Your application for work at 892 W Boston Boulevard, Detroit

Your application is scheduled to be heard at the Detroit Historic District Commission meeting on **Wednesday, May 13, 2026 at 4:30 PM**. Your application is subject to a public hearing.

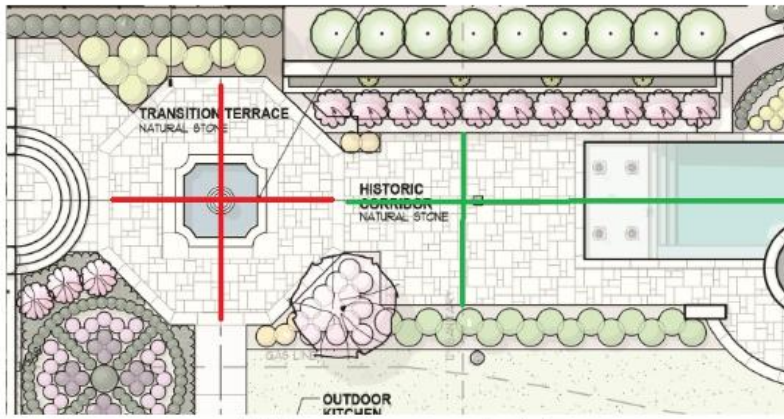
- What are the dimensions of the existing, following components: transition terrace, patio, and path to the north fountain? (See below marked-up, black and white screenshot from your materials of the areas shown in red, green, and blue.)

RED AREA: 342 s.f. existing

GREEN AREA: 955 s.f. existing

BLUE AREA: 360 s.f. existing

PURPLE AREA: 192 s.f. existing

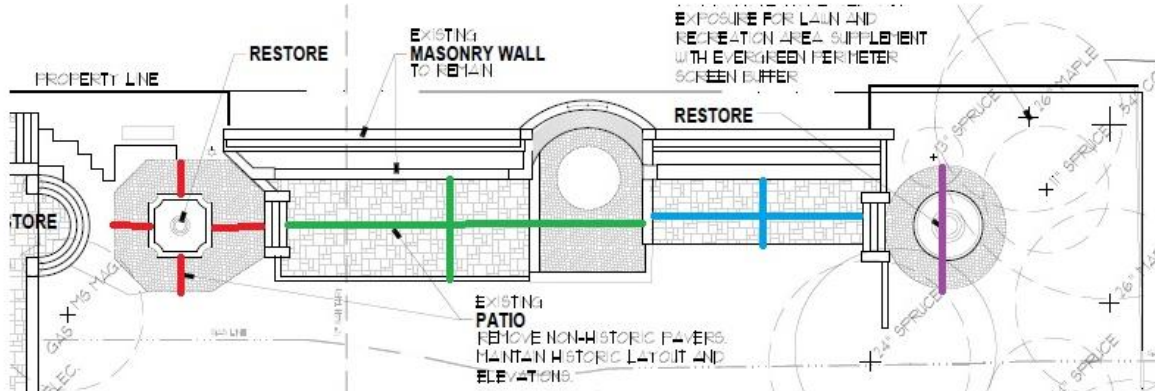
- What are the dimensions of the proposed, following components:
 - transition terrace and
 - patio/pool deck, both in front of the historic wall and at its widest, rounded point? (See your below color rendering as a screenshot and marked with my red and green lines.)

RED AREA 342 s.f. proposed

GREEN AREA (POOL DECK): 1,070 s.f. proposed

BLUE AREA (POOL): 760 s.f. proposed

PURPLE AREA: 0 s.f. proposed (lawn)
